ADDENDUM #1

Date: February 20, 2013

Project: CFA A Rehearsal Hall AHU Replacement

Annual Major Maintenance FY 13

A-1

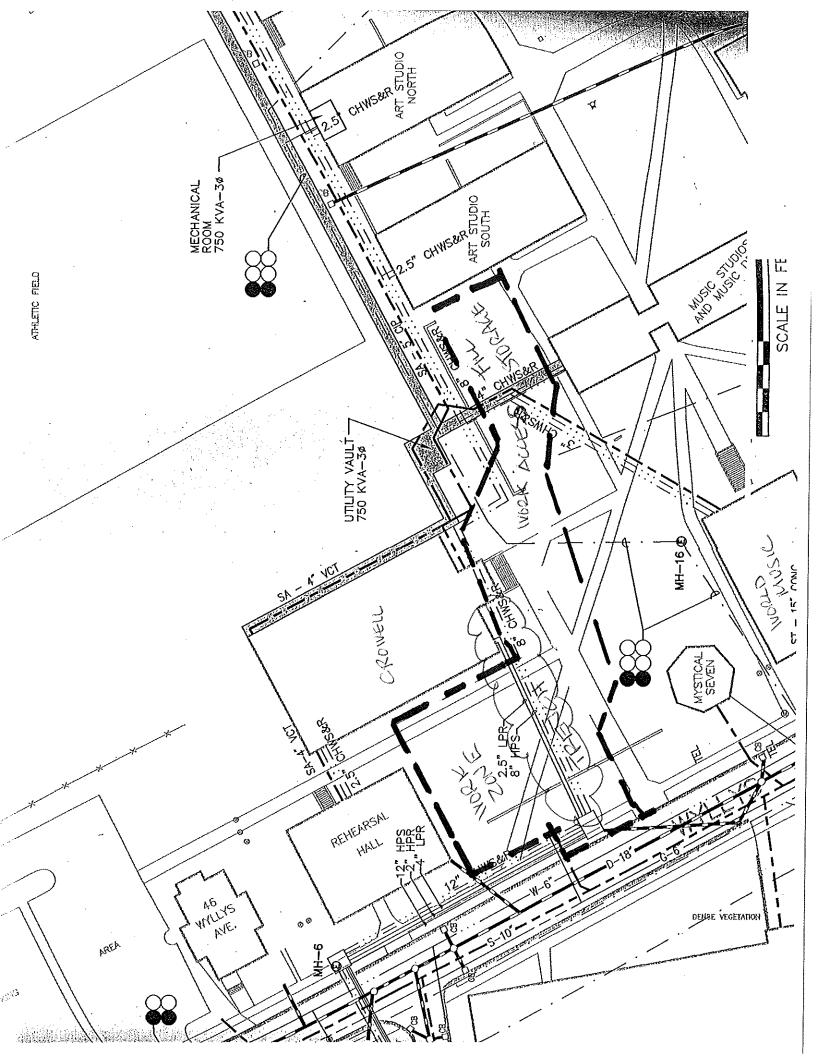
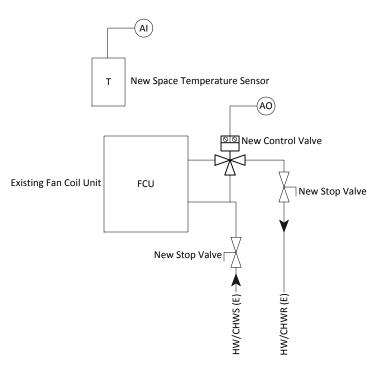
- 4. Revised Sheet A-1, note 6:
 - a. Install new 3" thick acoustical ceiling panels. Acoustical panels shall be Conwed Response type: "Soft Texture" as manufactured by Conwed Designscape, 800 Gustafson Road, Ladysmith, WI 54848 (www.conweddesignscape.com)
- 5. Table of Contents, Division 0, Division 1, Exhibits and Attachments posted to website 2/25/13

Fan Coil Piping Schematic Not To Scale

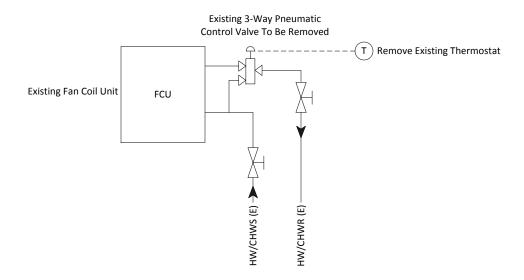
- 1. Valve configuration drawing attached from Automated Logic for the first floor fan coil units. Belimo 3-way valves to be installed. Reference attached drawing CFA-A-AutomatedLogic.
